## ORIGINATION FORM

Proposed Revisions to a Standard Plans Index  
(Please provide all information — Incomplete forms will be returned)

Index Number: 649-010

Index Title: Steel Strain Pole

HANDHOLE

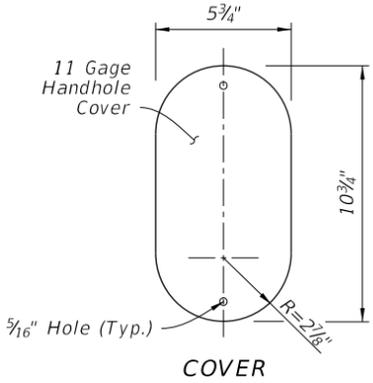
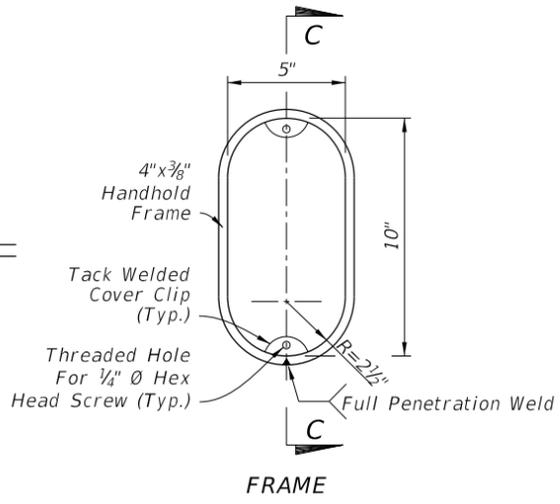
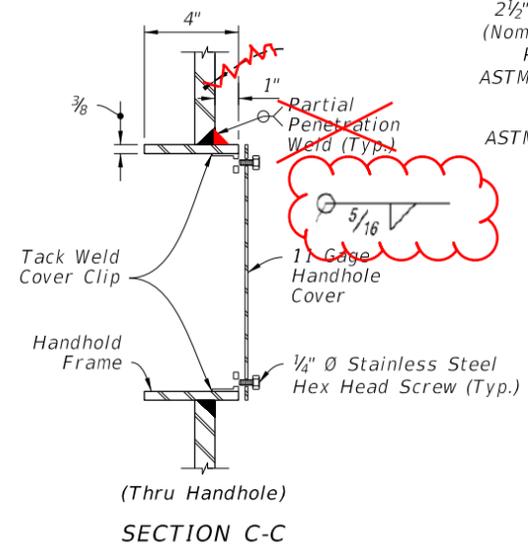
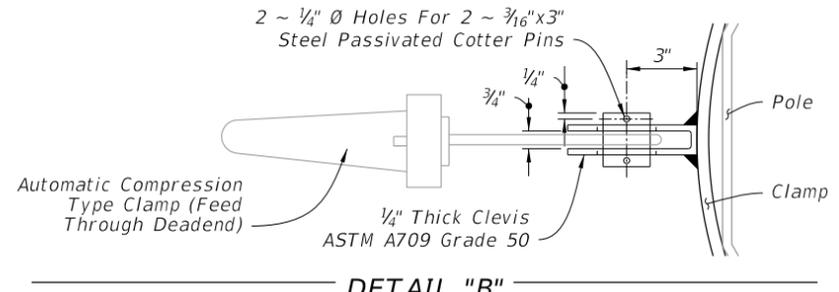
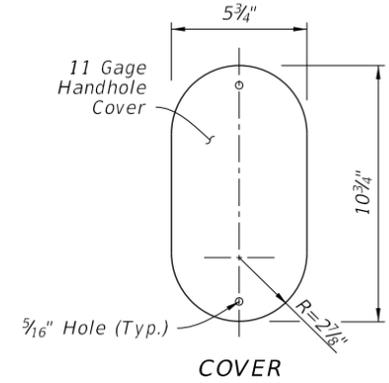
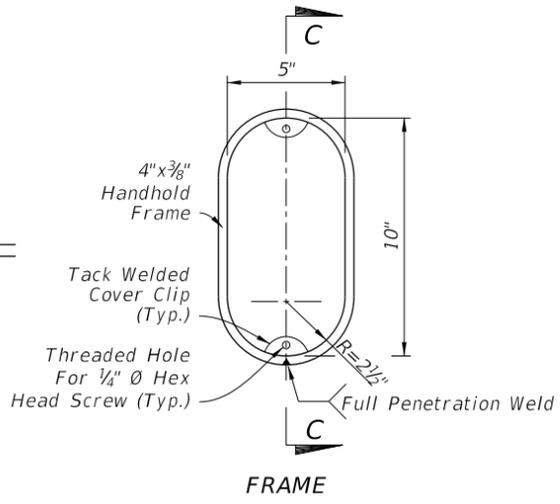
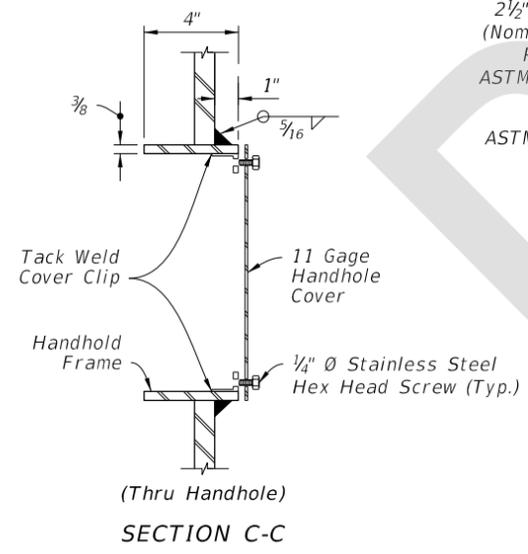
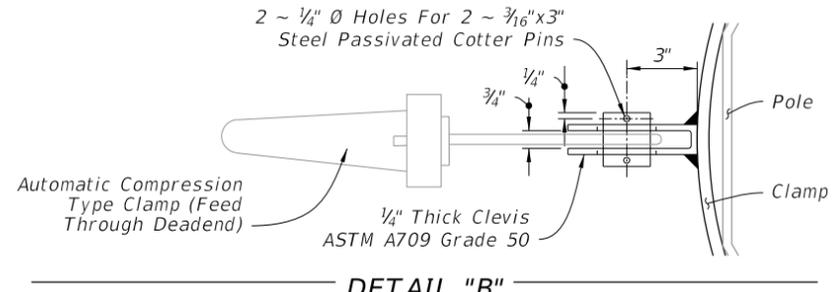
Sheet 3: Change weld on Handhole.
